7-ELEVEN
CONVENIENCE STORE WITH FUEL
7430 204TH STREET NORTHEAST
ARLINGTON, WA 98223
CITY OF ARLINGTON

7-ELEVEN
PRAIRIE CREEK VILLAGE
ARLINGTON, WA
COVER SHEET

7-ELEVEN
PRAIRIE CREEK VILLAGE
ARLINGTON, WA
SITE PLAN AS-BUILT

7-ELEVEN
PRAIRIE CREEK VILLAGE
ARLINGTON, WA
GRADING AND DRAINAGE AS-BUILT
C-20

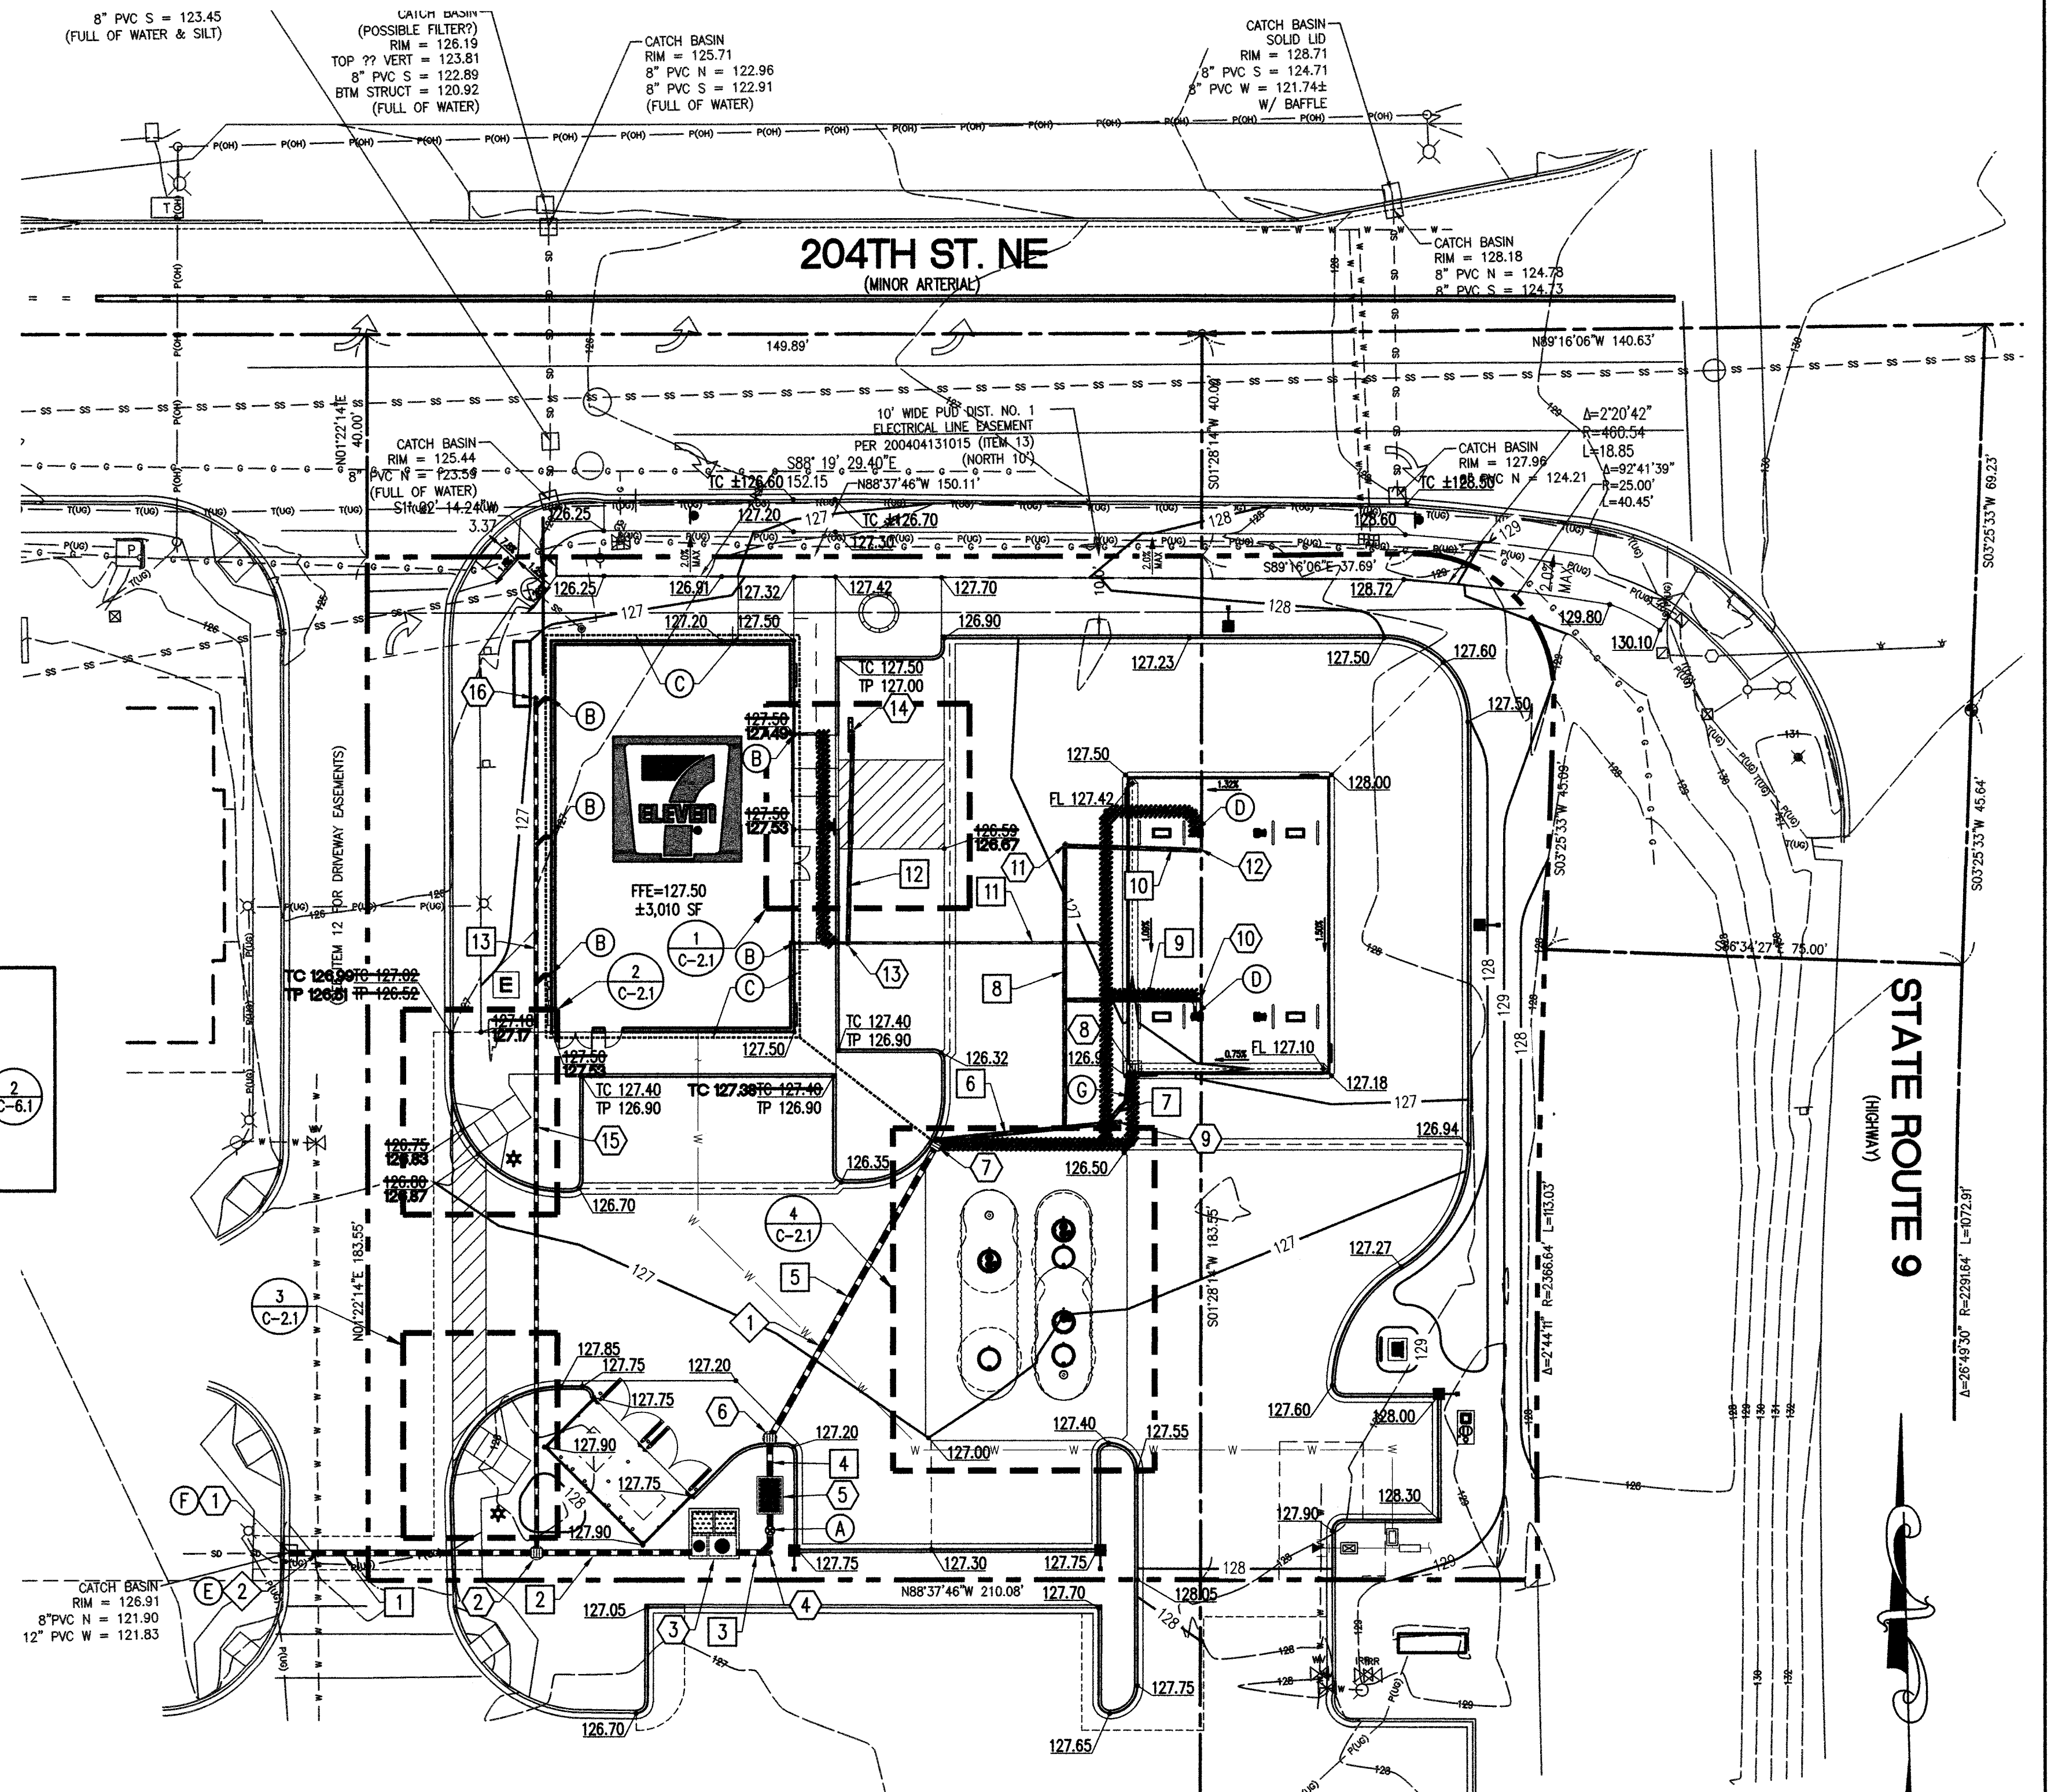
- (F) CORE DRILL INTO EXISTING CATCH BASIN TO INSTALL NEW STORM PIPE. GROUT AROUND PENETRATION USING A NON-SHRINKING MORTAR TO OBTAIN A WATER TIGHT CONNECTION. CONTRACTOR SHALL ENSURE THE STRUCTURAL INTEGRITY OF THE EXISTING MANHOLE IS NOT COMPROMISED AS A RESULT OF THE ADDED PIPE CONNECTION. NEW 12" PIPE NOT INSTALLED. EXISTING 8" PIPE USED.

RIM=126.91
IE(EX 8"N)=±121.90
IE(EX 12"W)=±121.83
IE(12"E)=121.83
IE(EX 8"E)=±121.83 | 2 PVC CATCH BASIN, SL
RIM=±126.25 127.44
IE(12"E,W)=±122.05 122.09
IE(8"N)=±122.05 121.99
IE(8"W)=122.03 | 3 MODULAR WETLAND
RIM=±126.10 128.51
IE(12"W)=±122.19 122.46
IE(8"N)=±122.05 121.99
IE(12"E)=±123.69 123.90 | 4 SDCO
RIM=ATG
IE=123.72 | 5 O/W SEPARATOR
RIM=±126.10 128.15
IE(12"N,S)=±123.76 123.99
SEE DETAIL 1, SHEET C-6.2 |

RIM=±127.15 127.13
IE(12"N,S)=±123.88
IE(12"NE)=124.01
IE(12"S)=123.99 | 7 PVC CATCH BASIN, GR
RIM=±126.20 126.25
IE(12"S)=±124.10 124.15
IE(8"E)=±124.10 124.09
IE(8"4"NW)=±124.10 124.43 | 8 TYPE 1 CB, PGR
RIM=±126.60 126.76
IE(6"S)=±124.57 124.68
STRUCTURE MUST PROVIDE A MINIMUM 3' SUMP BELOW OUTLET PIPE INVERT FOR SPILL CONTROL. | 9 SDCO
RIM=ATG 126.65
IE=124.45 | 10 SDCO
RIM=ATG 127.08
IE=124.80 |

RIM=ATG 127.05
IE=125.00 | 12 SDCO
RIM=ATG 127.34
IE=125.16 | 13 SDCO
RIM=ATG 126.82
IE=125.27 | 14 SDCO
RIM=ATG 126.90
IE=125.65 | 15 SDCO NOT INSTALLED
RIM=ATG
IE=123.20 |

L=44' 30"
S=0.50% | 2 12" CPEP
L=28' 32"
S=0.50% 1.16% | 3 12" CPEP
L=44' 11"
S=0.50% 0.80% | 4 12" CPEP
L=7' 6"
S=0.50% 0.0% | 5 12" CPEP
L=64' 62"
S=0.50% 0.21% |

L=35' 33"
S=1.00% 1.40% | 7 6" CPEP
L=13' 10"
S=1.00% 1.40% | 8 6" CPEP
L=66' 51"
S=1.00% | 9 6" CPEP
L=19' 24"
S=1.00% | 10 6" CPEP
L=19' 24"
S=1.00% |

L=56' 39"
S=1.00% | 12 4" CPEP
L=38'
S=1.00% | 13 8" CPEP
L=153'
S=1.50% | | |

7-ELEVEN
 PRAIRIE CREEK VILLAGE
 ARLINGTON, WA
 UTILITY PLAN AS-BUILT
 C-30

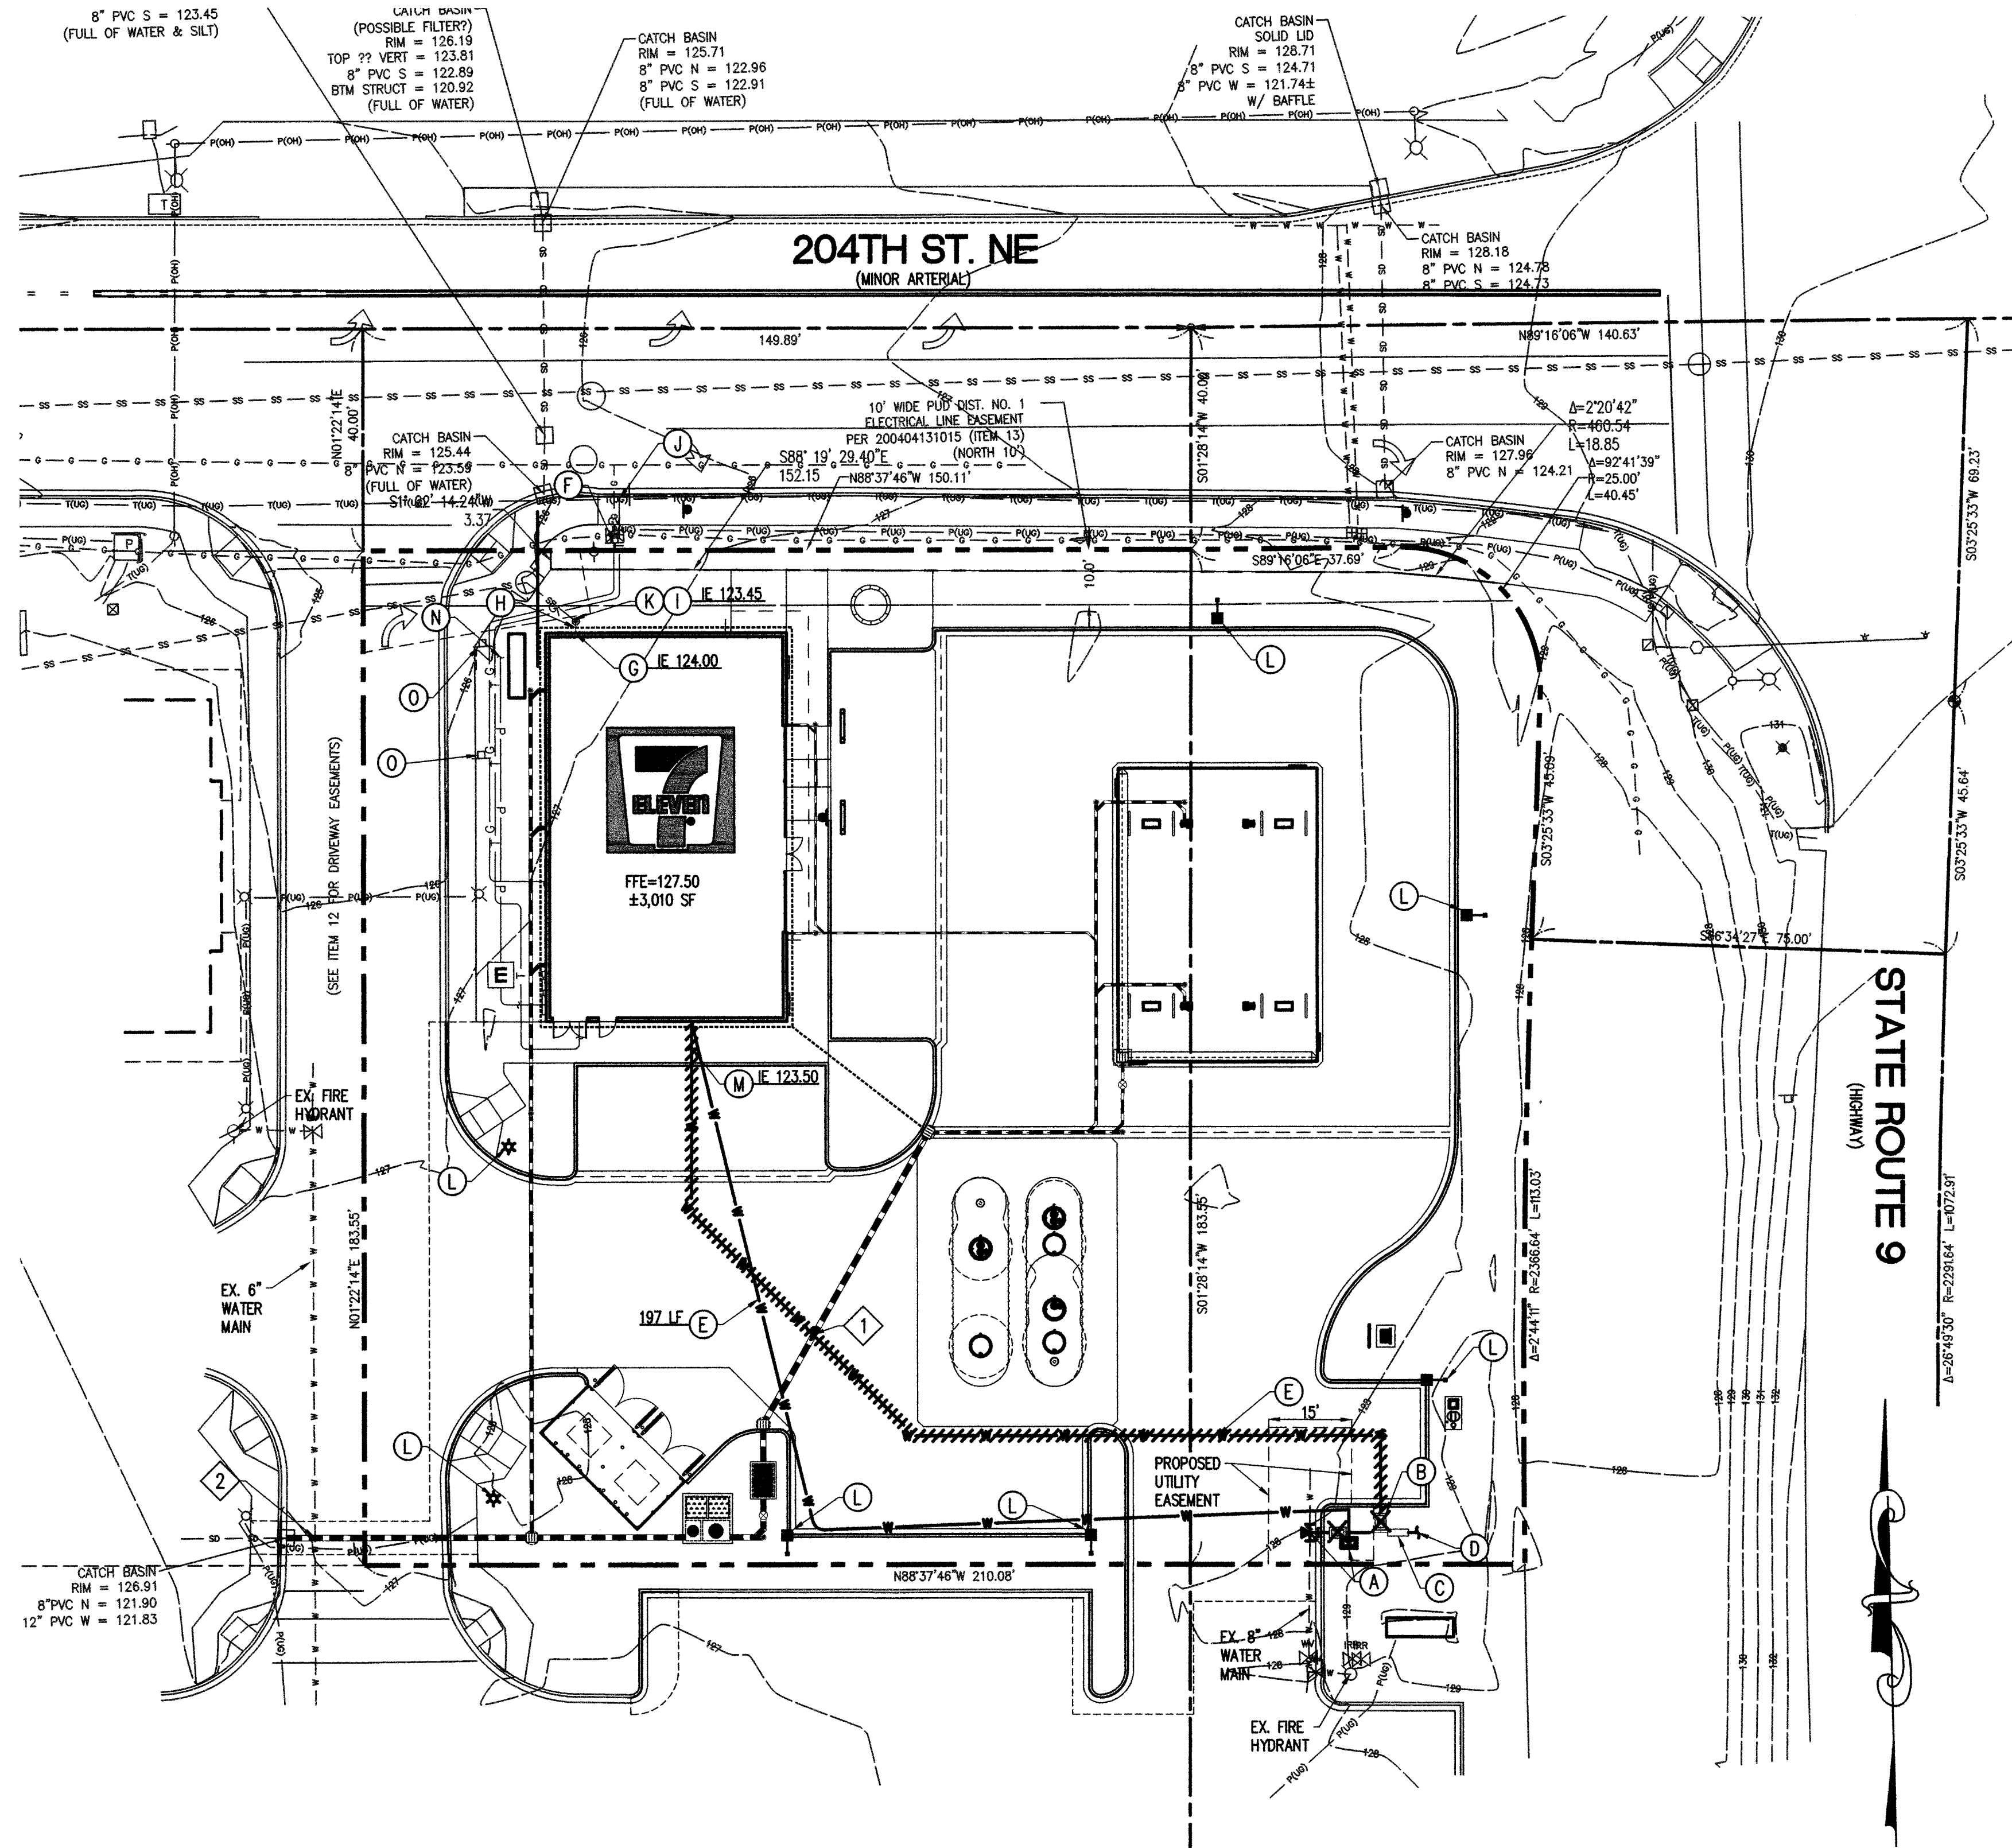
- (1.2 / C-7.0) (A) INSTALL 2" COMMERCIAL DOMESTIC WATER SERVICE WITH 1" METER, PER COA STANDARD DETAIL W-050.
- (4 / C-7.0) (B) INSTALL 1" RPBA, PER COA STANDARD DETAIL W-130. **INSTALLED IN BUILDING**
